PARKLANDS VILLAGE 2 PHASE 2

DATE:
06/07/2023 SITE PLAN 01

SHEET TITLE:
LANDSCAPE
PLAN

PARKLANDS VILLAGE 2 SUBDIVISION FILING NO. 2

FIGURE 16
PARKLANDS VILLAGE 2
AURORA, COLORADO
2029 TOTAL TRAFFIC VOLUMES

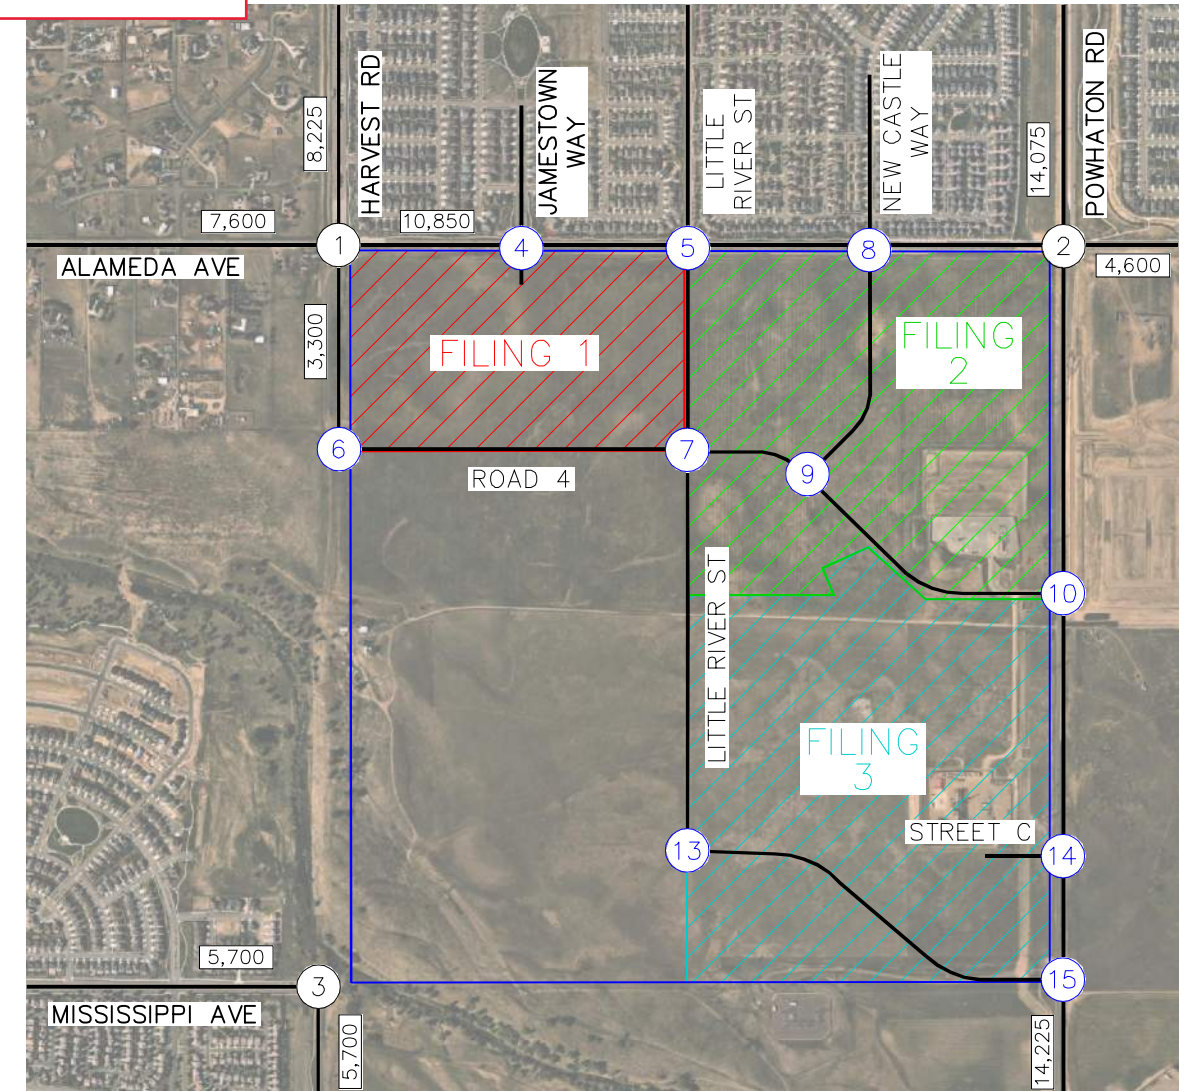
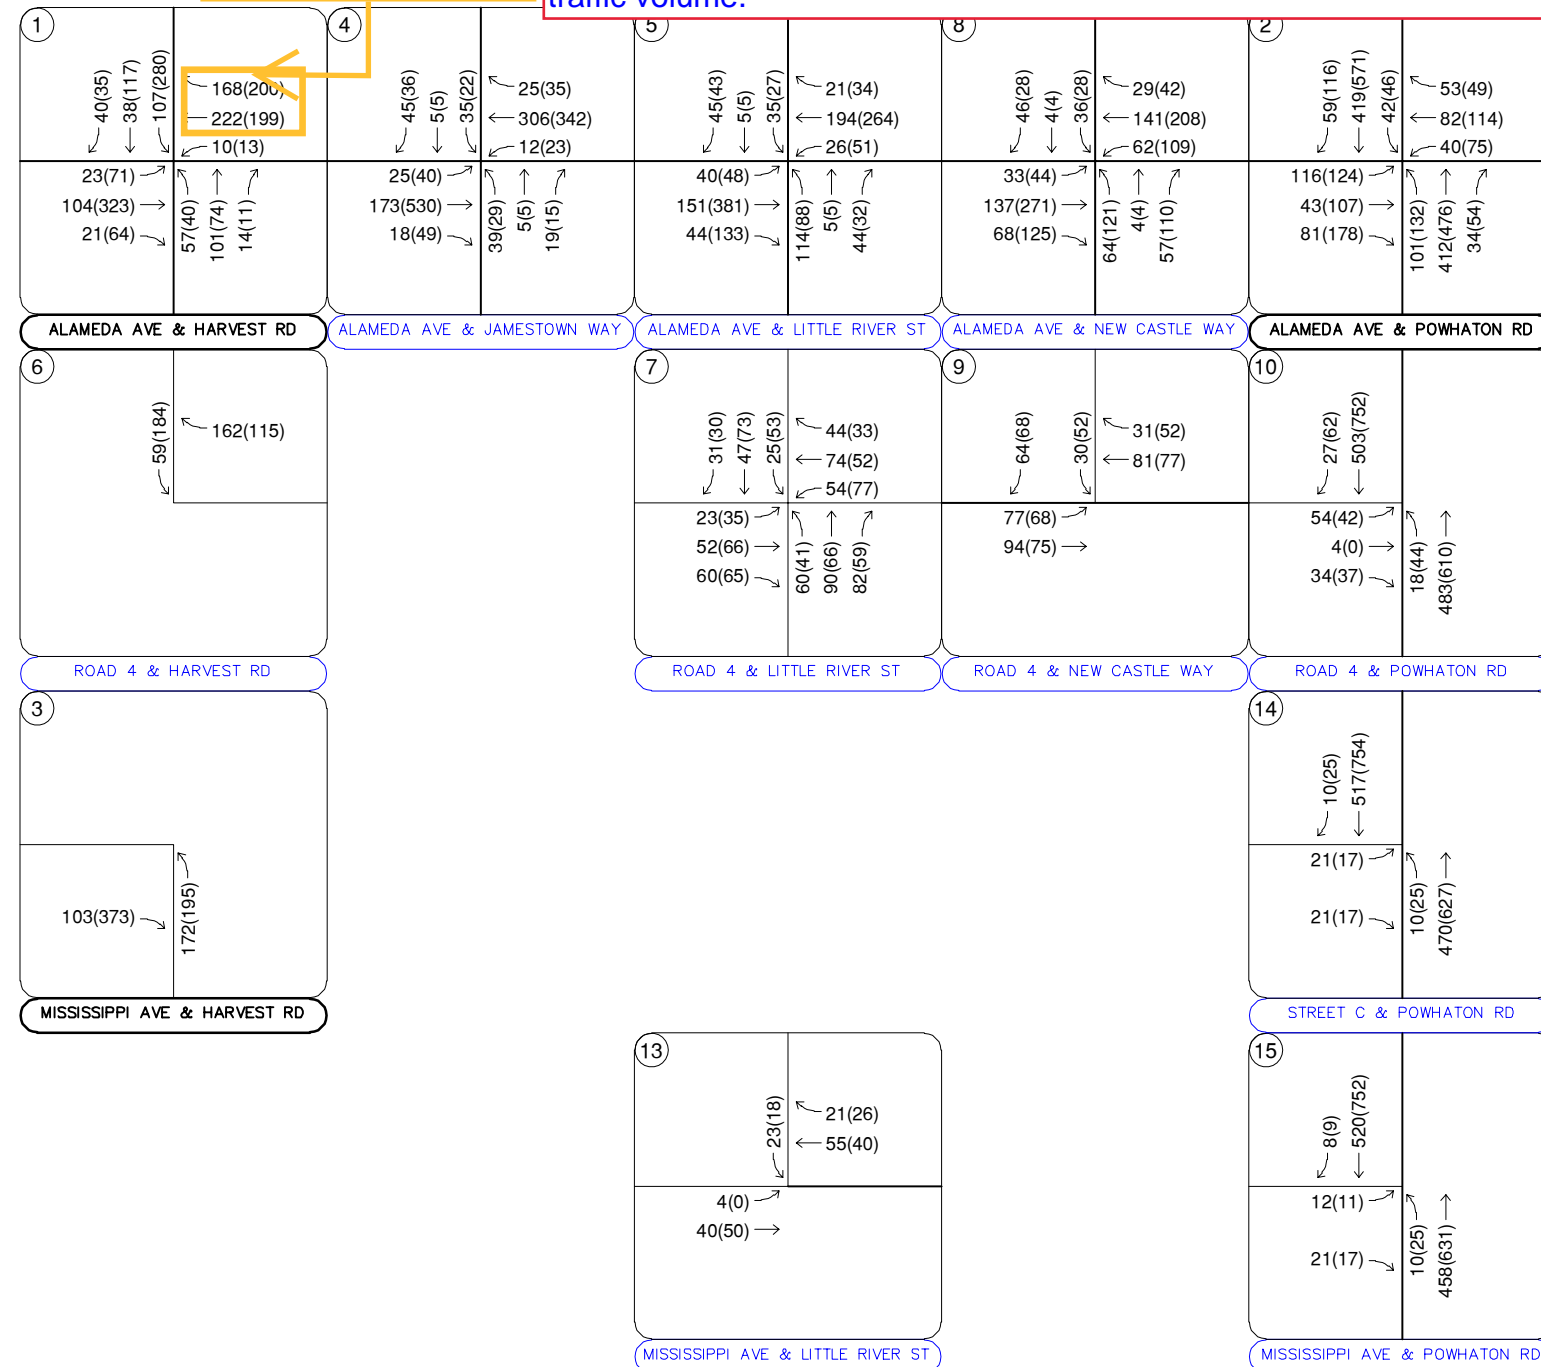
Issue with high adjacent throughs and no right turn lane

This condition is expected to be temporary, as in Filing 4 (2031 horizon) the Harvest Road connection from Mississippi Ave to Alameda Ave will be completed, resulting in a significant decrease in both westbound through and westbound right turning movements -- at which point a westbound right turn lane would not be needed. In addition to this, during this temporary condition the intersection is expected to operate acceptably with this geometry in this horizon. It is believed providing this westbound right turn lane for a temporary condition would result in overbuilding the roadway for its ultimate expected traffic volume.
